UNITED STATES PATENT AND TRADEMARK OFFICE

APPLICATION NO.	FILING DATE	FIRST NAMED INVENTOR	ATTORNEY DOCKET NO.	CONFIRMATION NO.
10/036,064	10/19/2001	Richard H. Norris	Norris 11	3888

Office Action Summary

DETAILED ACTION

CABLE END CAPS

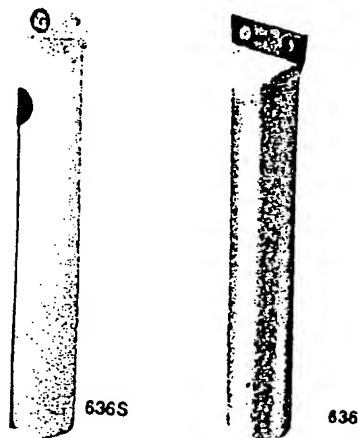
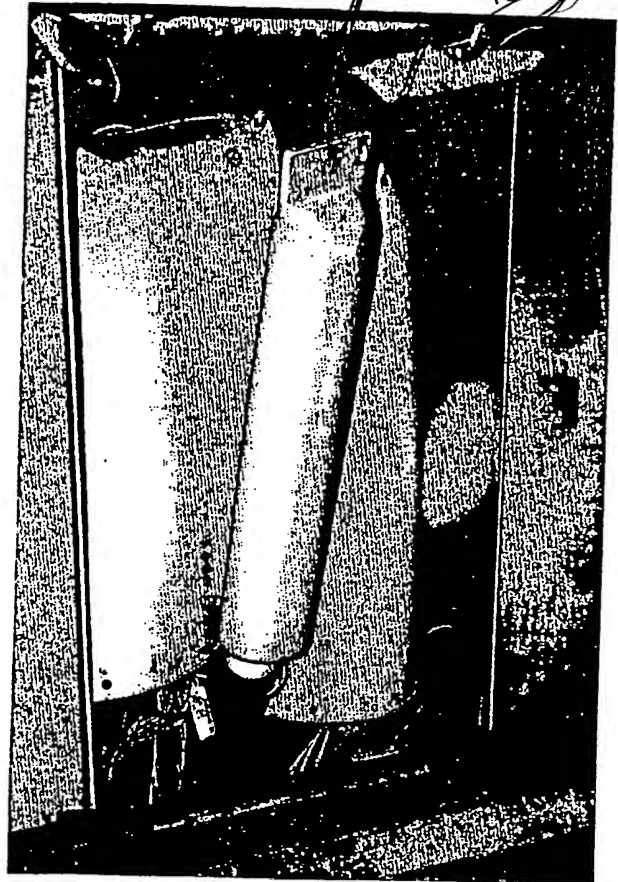
6. Claims 1, 4, 6-9, 13, 17, 19 and 20 and 22 are rejected under 35 U.S.C. 102(b) as being anticipated by Siebe inc/Salisbury (W H) and Co (cited in IDS).

Siebe inc/Salisbury (W H) and Co discloses a transmission medium, an outer jacket, disposed about the transmission medium and an end cap swaged on the end of the transmission cable, a ring (see marked figure attached), immovable, seals, shape.
